Housing Development,  
Mooreville, Rathdowney, Co Laois

Stage 1 Road Safety Audit

<b>Document Ref:</b>	<b>P20-060-RSA-PD-RP-001</b>
----------------------	------------------------------

*Location: Drawing MV-ROD-00-XX-DR-C-0005 (Rev. P01)*

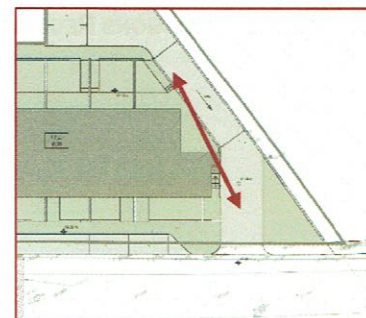
*Summary: Proposed parallel parking provision encroaches on the existing raised signalised pedestrian crossing on the R435.*

The proposed parallel parking is indicated in close proximity to and, in relation to space no. 1, encroaching onto the existing raised signalised pedestrian crossing on the R435. It is unclear if it is proposed to remove this crossing. If this crossing is not removed vehicles entering and exiting the parallel parking spaces, particularly spaces 1 and 2, will conflict with the operation of the crossing which could lead to driver discomfort as they ascend/descend the ramp or to collisions with vulnerable road users crossing the R435.

To facilitate the proposed parallel parking spaces the existing signalised crossing should be relocated.

3.1	Yes	Yes	Pedestrian crossing to be moved to north-west (approx. 2.5m) so the parking does not encroach on the crossing.	
3.2	Yes	Yes	The 3 No. spaces at the rear of the site will be assigned to each house, therefore only drivers who know the road should be using it. Cars will travel slowly on the road. Drivers at the top of the road (parking side) will give way to oncoming traffic (line markings and signage to be shown at detailed design stage). Mirrors to be included to provide drivers with enhanced sightlines.

*Location: Drawing MV-ROD-00-XX-DR-C-0005 (Rev. P01)*

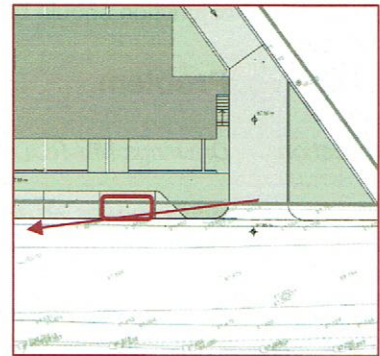
*Summary: It is unclear if there is sufficient space within the access road carriageway for safe two-way traffic.*

The width of the internal access road within the proposed development has not been specified and it is therefore unclear if the carriageway will be sufficiently wide enough for two vehicles to pass each other safely. The swept path drawings provided indicate that while sufficient space for two-way traffic may be available on the immediate approach to the site access it is unlikely that two vehicles will be able to pass each other safely within the carriageway adjacent the site's eastern boundary which could lead to low speed head-on collisions.

This problem may be exacerbated by the potential for the corner of the easternmost residential unit to restrict a driver's forward visibility thus increasing the risk of head-on collisions.

Ensure sufficient forward visibility is maintained within the development.

*Location: Drawing MV-ROD-00-XX-DR-C-0005 (Rev. P01)*

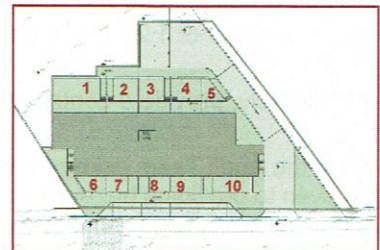
*Summary: Vehicles parked in the proposed parallel parking spaces may restrict a driver's visibility to the west when exiting the site.*

The proposed parallel parking spaces to the west of the site access, when occupied, may restrict a driver's visibility in this direction when exiting the site. This could lead to drivers exiting the site onto the R435 when it is unsafe to do so resulting in side-on collisions with vehicles on the R435.

Ensure vehicles parked in the parallel parking spaces do not impede a driver's visibility when exiting the site of the proposed development.

3.3	Yes	Yes	Car parking to move to north-west to provide sufficient sightlines (approx 2.5m).	
3.4	Yes	No	Laois CoCo have requested that the number of parking spaces be kept to a minimum.	Yes

*Location: Drawing MV-ROD-00-XX-DR-C-0005 (Rev. P01)*

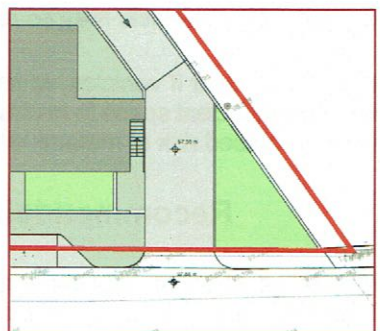
*Summary: It is unclear if the proposed parking provision will be sufficient for the number of residential units within the proposed development.*

A total of 7No parking spaces have been indicated within the proposed development, 3No on-curtilage spaces to the rear of the proposed residential units and 4No parallel parking spaces on the R435 adjacent the development. The number of units proposed within the development is unclear although the Audit Team have assumed that there will be a minimum of 10No units due to the number of accesses indicated within the site.

It is therefore unclear if the proposed parking provision will sufficiently cater for the number of residents and any visitors which may visit the development. If sufficient parking is not provided this could lead to residents, or visitors, parking in unsafe locations within the site or on the R435 resulting in an increased risk of collisions.

Ensure the proposed parking provision is sufficient for residents and visitors.

*Location: Drawing MV-ROD-00-XX-DR-C-0005 (Rev. P01)*

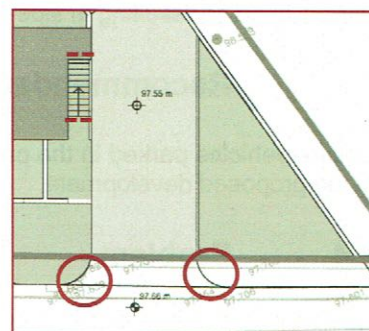
*Summary: Junction control has not been indicated at the junction of the site access and the R435.*

The control of the junction of the site access and the R435 has not been indicated. It is therefore unclear if the junction will operate under Stop, or Yield, control. Each type of junction control requires different visibility requirements on approach to the junction, with a Yield control junction requiring more onerous requirements. It is unclear if the visibility requirements for a Yield junction will be achieved on the approach due to the adjacent property boundary to the east and the proposed residential units to the west. If sufficient visibility, for the necessary type of junction control, is not provided this could lead to driver's being insufficiently aware of the junction on the approach, and the need to slow their vehicle or stop completely, with an increased risk of overshooting into the R435 carriageway and side-on collisions.

A Stop control junction should be provided at the site access.

3.5	Yes	Yes	Stop road markings and Stop signs to be shown on drawings at detailed design stage.	
3.6	Yes	Yes	Dropped kerbs and tactile paving to be provided on both sides of the crossing. They will be shown at detailed design stage.

*Location: Drawing MV-ROD-00-XX-DR-C-0090 (Rev. P01)*

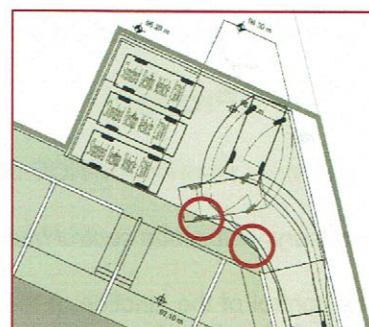
*Summary: Swept path of a reversing vehicle is indicated as mounting the footpath.*

The swept path analysis drawings indicate the wheel of a vehicle mounting the footpath at the rear of the proposed development when entering and reversing within the site. There is a risk of material damage to the kerb/footpath and vehicles should a vehicle mount/strike the footpath when reversing.

Also, there is an increased risk of collisions between vehicles and pedestrians should a vehicle overhang the footpath, particularly when undertaking a reversing manoeuvre as a driver's visibility to a pedestrian to the rear of their vehicle may be restricted.

It is also unclear if vehicles, which park nose-in at the 3No parking spaces to the rear of the residential units will have sufficient space to reverse out of a parking space if the adjacent parking spaces are occupied resulting in an increased risk of material damage collisions.

Ensure all vehicles can undertake turning manoeuvres within the proposed development safely without impeding on adjacent footpaths or striking other vehicles or boundary walls.

A swept path analysis should be undertaken to determine if all of the parking spaces are sufficiently accessible within the space available, particularly when adjacent spaces are occupied.

3.7	Yes	Yes	Turnabout area to be increased to allow more comfortable turning and to ensure all spaces are accessible.

## Appendix D – Problem Locations

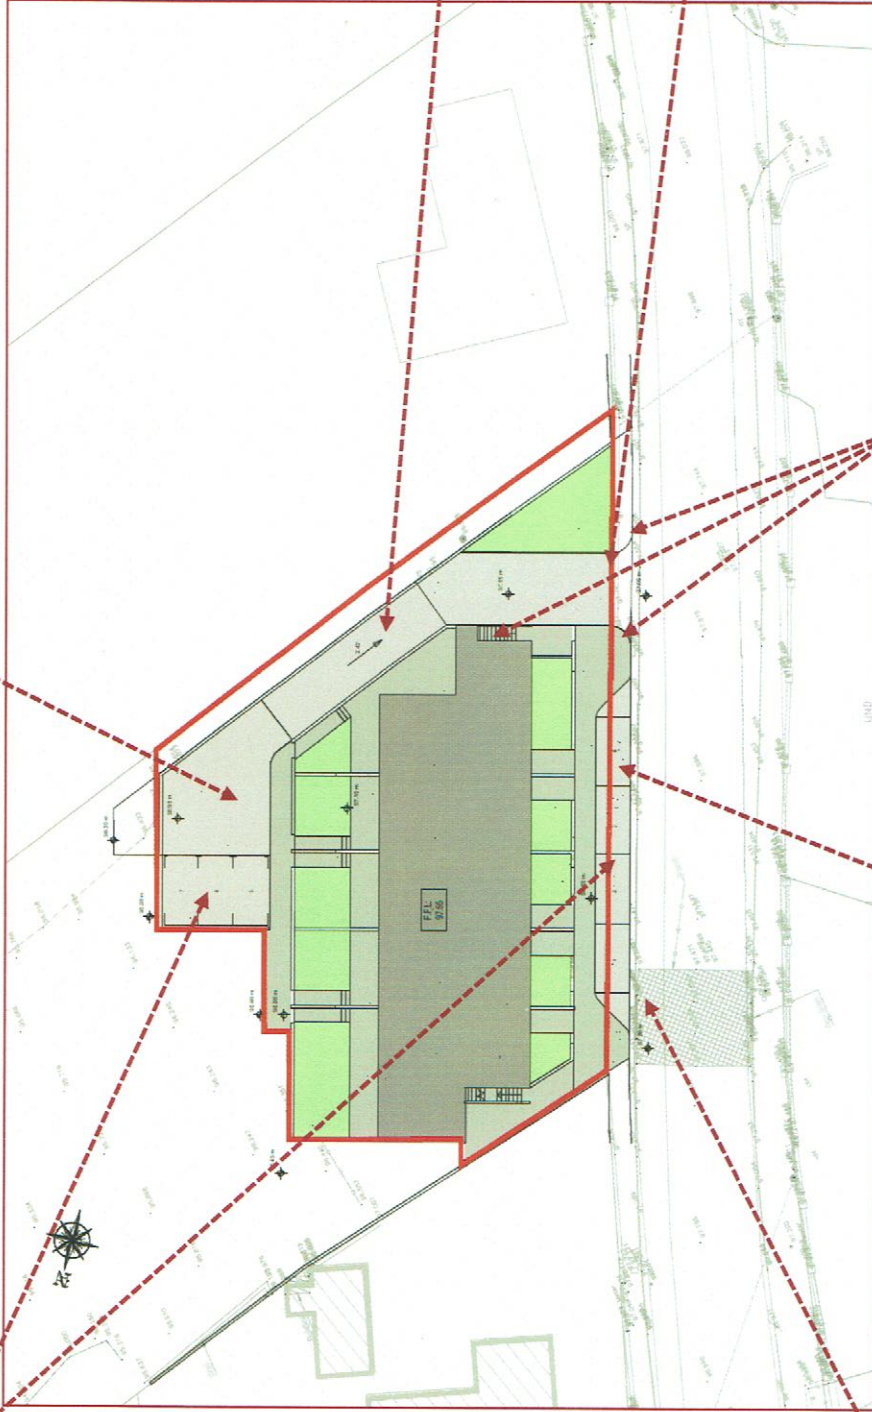
**Problem 3.4:** It is unclear if the proposed parking provision will be sufficient for the number of residential units within the proposed development.

**Problem 3.7:** Swept path of a reversing vehicle is indicated as mounting the footpath.

**Problem 3.2:** It is unclear if there is sufficient space within the access road carriage-way for safe two-way traffic.

**Problem 3.5:** Junction control has not been indicated at the junction of the site access and the R435.

**Problem 3.1:** Proposed parallel parking provision encroaches on the existing raised signalised pedestrian crossing on the R435.

**Problem 3.3:** Vehicles parked in the proposed parallel parking spaces may restrict a driver's visibility to the west when exiting the site.

**Problem 3.6:** While details of dropped kerbs and tactile paving have been provided, they have not been indicated within the proposed development.
